Access Compliance Report

Public Rights-of-Way

(Curb Ramps)

Intersection ID: N/A	Main Street: DOWNS_RD	Cross Street: E WESTINHOUSE BV	Location: NW
ADA ID: DBB4CE97F93A	Ramp Type: Perp	Initial Pass/Fail: Fail	Overall Compliance: No
			Severity Score: 13.75

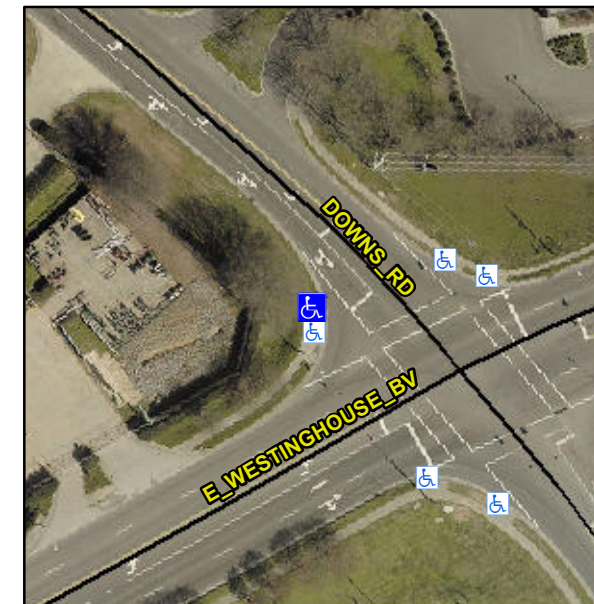
Not Found, R304.2.2, R304.5.3

Compliance	Description	Data	Compliance	Description	Data
N/A	Ramp Length (in)	94.0	No	Ramp Slope (%)	9.0
Yes	Ramp Width (in)	48.0	No	Ramp XSlope (%)	3.5
N/A	Flare Type LT	N/A	N/A	Flare Type RT	N/A
N/A	Flare Slope LT (%)	N/A	N/A	Flare Slope RT (%)	N/A
N/A	Flare Traversable LT?	N/A	N/A	Flare Traversable RT?	N/A
N/A	Landing Length (in)	N/A	N/A	DWS Provided?	N/A
N/A	Landing Width (in)	N/A	N/A	DWS Contrast?	N/A
N/A	Landing Slope (%)	N/A	N/A	DWS Length (in)	N/A
N/A	Landing X Slope (%)	N/A	N/A	DWS Full Width?	N/A
N/A	Landing Curb? (Y/N)	N/A	N/A	DWS Offset (in)	N/A
N/A	Shared Landing?	N/A			
N/A	Gutter Ponding?	N/A	N/A	Gutter Slope (%)	N/A
N/A	Gutter Lip Ht (in)	N/A	N/A	Gutter X Slope (%)	N/A
N/A	Painted X Walk1?	Yes	N/A	Painted X Walk2?	N/A
	X Walk 1 Direction	To E		X Walk 2 Direction	N/A
N/A	X Walk 1 Width (in)	116.0	N/A	X Walk 2 Width (in)	N/A
	X Walk 1 Slope (%)	0.7		X Walk 2 Slope (%)	N/A
	X Walk 1 X Slope (%)	1.2		X Walk 2 X Slope (%)	N/A

**Remove & Replace Entire Ramp.
Restripe Crosswalk.**
